Preliminary Subdivision Plan DECISION

45 Beacon Street
Proposed Street Name: TBD

From: Phil Christiansen <philchristiansen.pe@gmail.com>
Sent: Thursday, August 3, 2023 1:38 PM
To: Benedetto, Mary; John Hargreaves
Cc: salamone_angelo@yahoo.com
Subject: Re: preliminary plan Angelo Salamone
Attachments: sheet 1 supplemental.pdf; rev sheet 3.pdf; Sheet 2 supplemental.pdf; SHEET 3 SUPPLEMENTAL.pdf

SHEET 1 OF 5

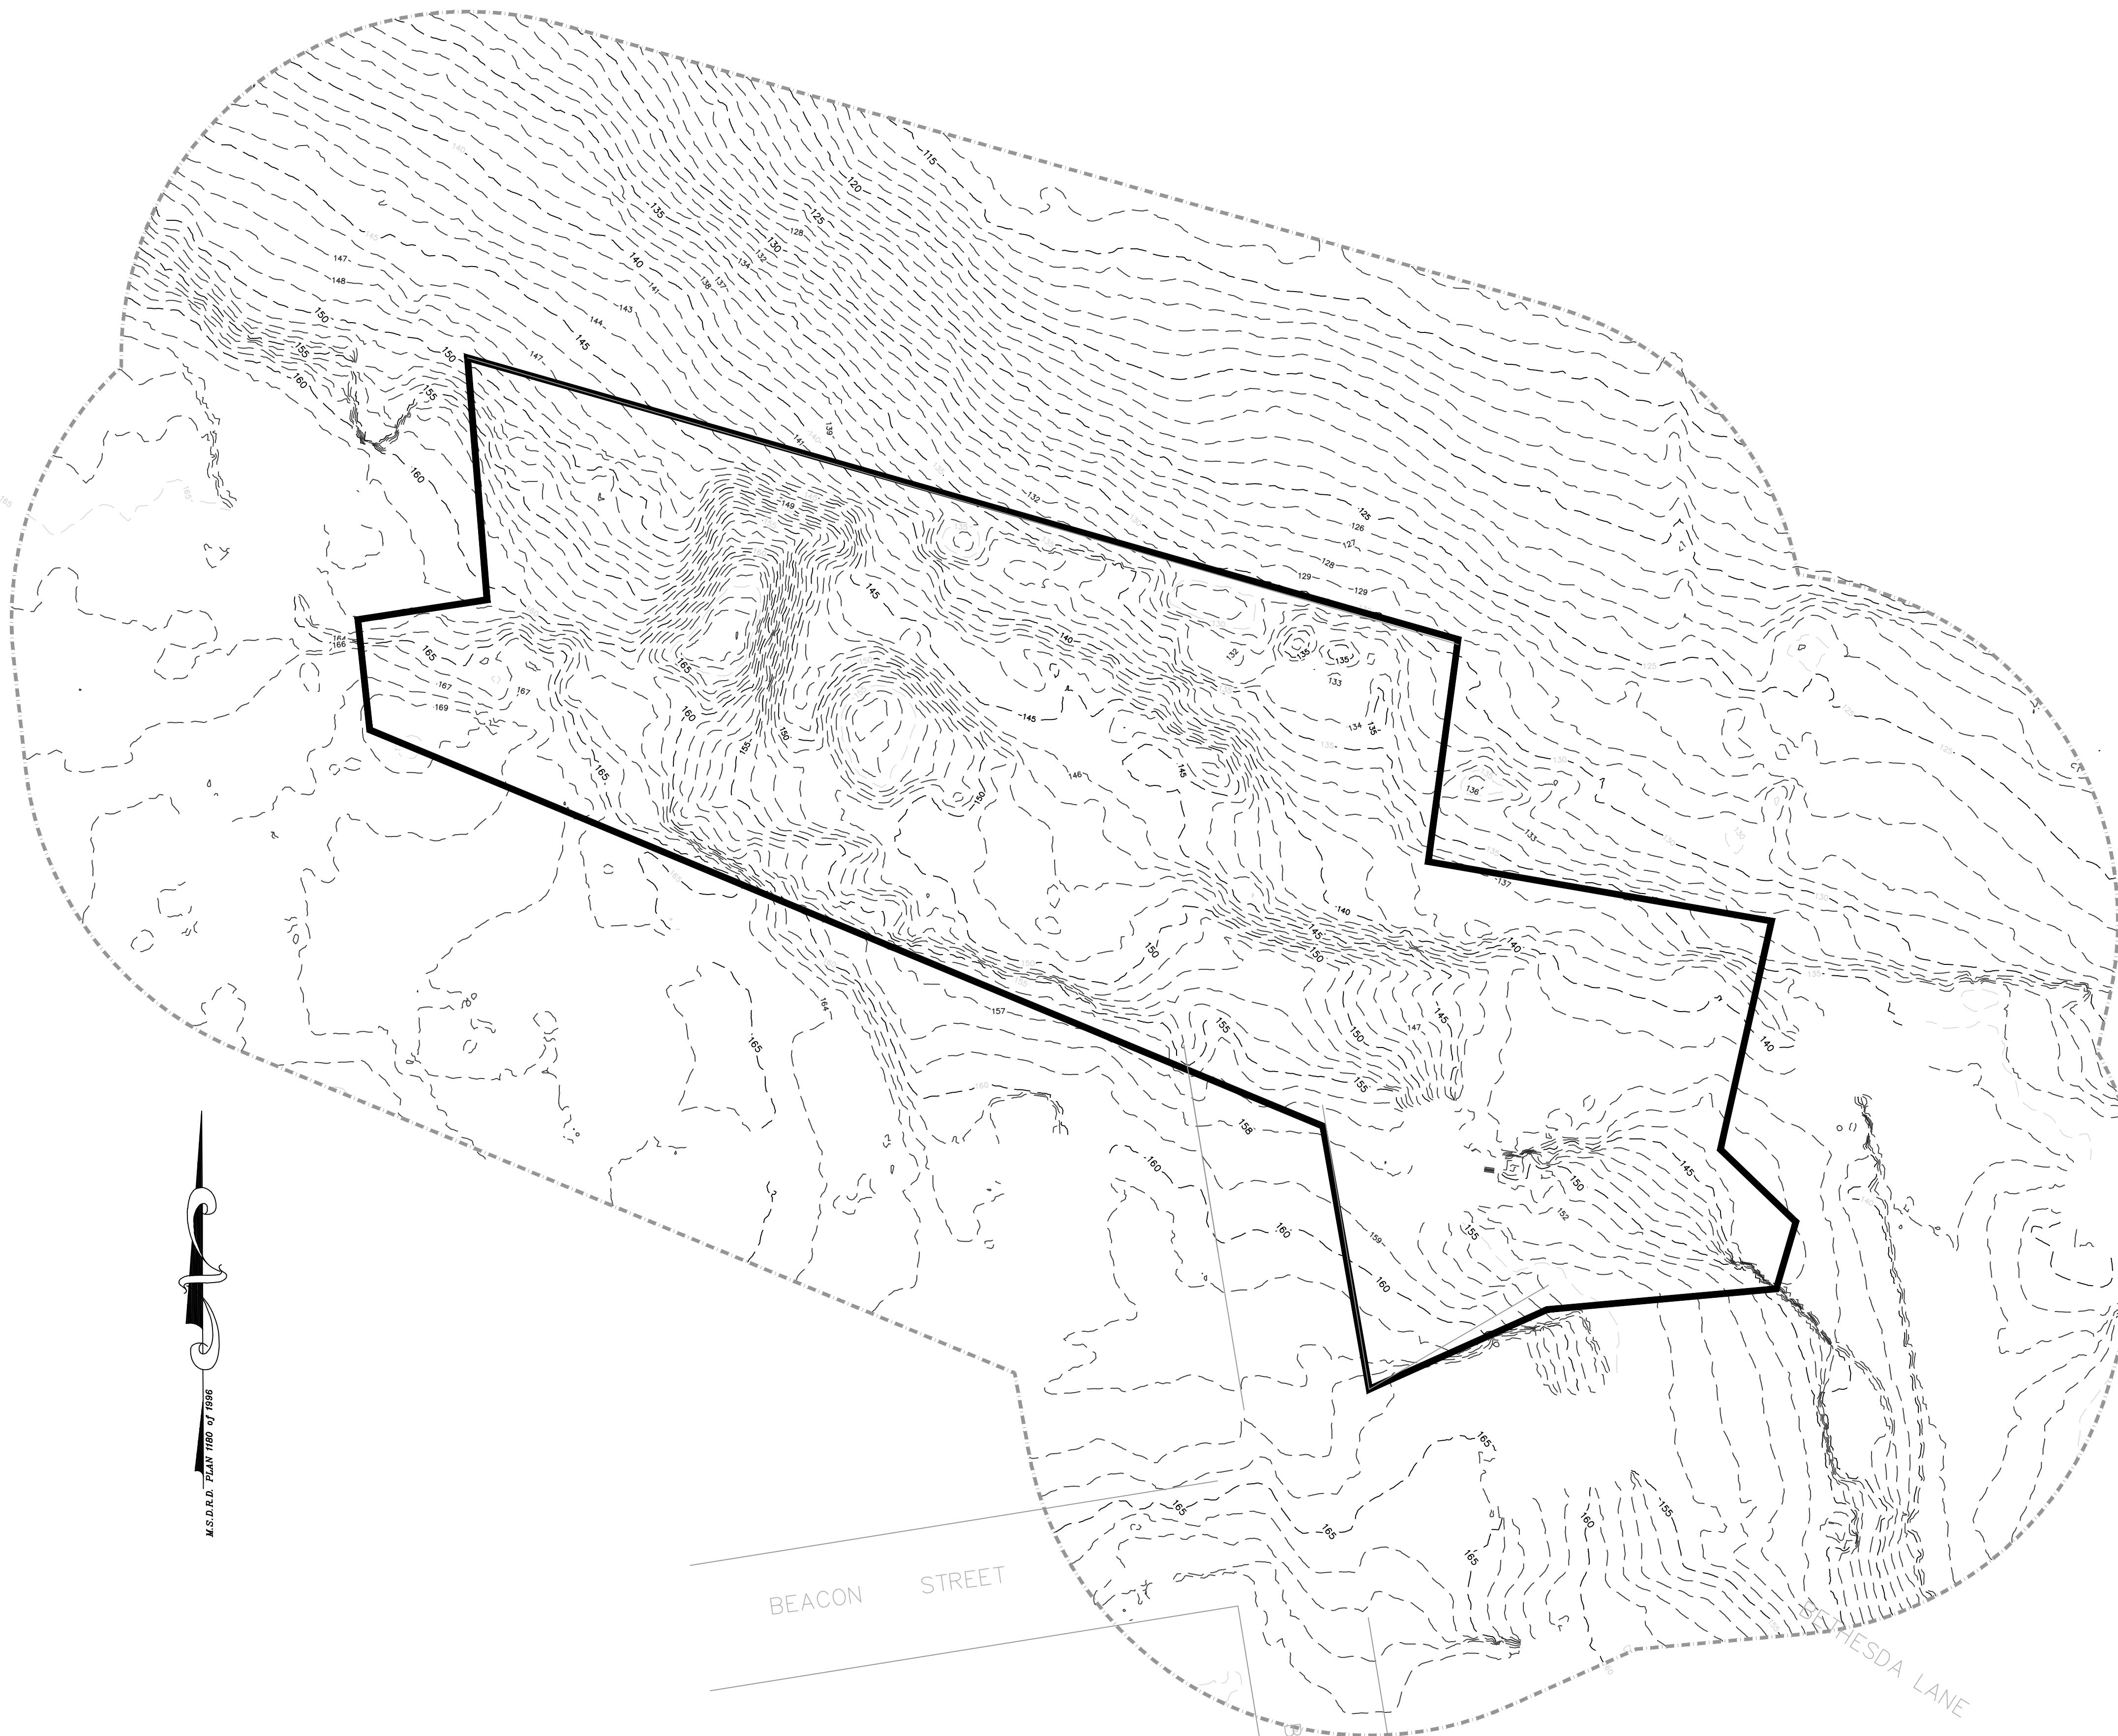
Item1. I have shown on the attached supplemental Sheet 1 an area where the applicant could widen the right of way to 60 feet. Such a widening of the right of way would require a variance from the frontage setback for 45 Beacon street and would provide the only 60 foot width in the entire street. Does not seem to be a reasonable requirement in an established neighborhood.

Item 4. I have shown the adjacent houses on Supplemental Sheet 1. I hope it will be easier to see the houses.

ROADWAY PROFILE

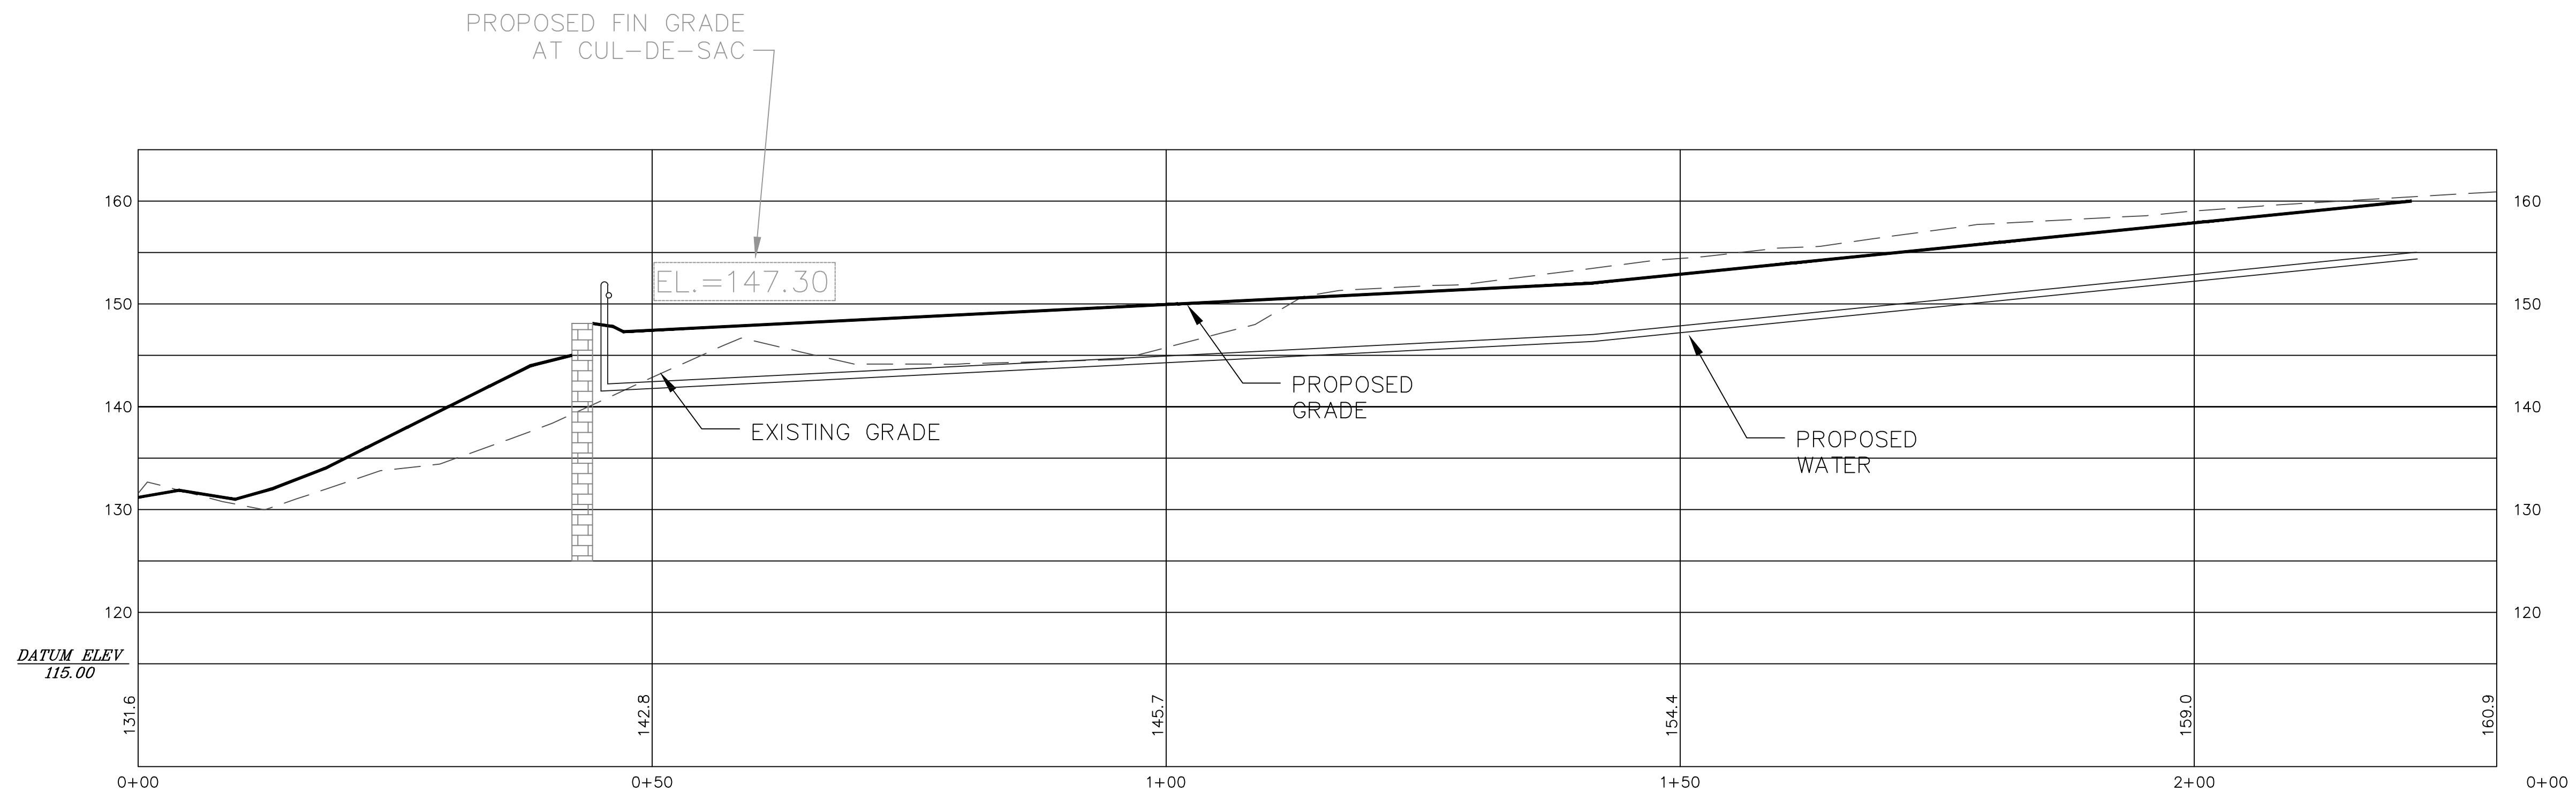
1. A waiver from Section 7.1.1a requiring a right of way width of 60-feet.
 - a. *The existing layout of Beacon Street is 40-feet wide and the Applicant proposes to extend the layout of Beacon Street at the 40-foot width, because of such the Applicant requests relief of this requirement.*
2. A waiver from Section 7.1.3 that cross sections conform to Figure One.
 - a. *The Applicant requests a waiver of the requirement due to the proposed 24-foot pavement width and request for no sidewalk and concrete curbing.*
3. A waiver from Section 7.1.5(b) requiring the maximum slope of a cul-de-sac be 3%.
 - a. *The Applicant requests a waiver to construct the cul-de-sac with a grade of 5% due to the steepness of the land.*
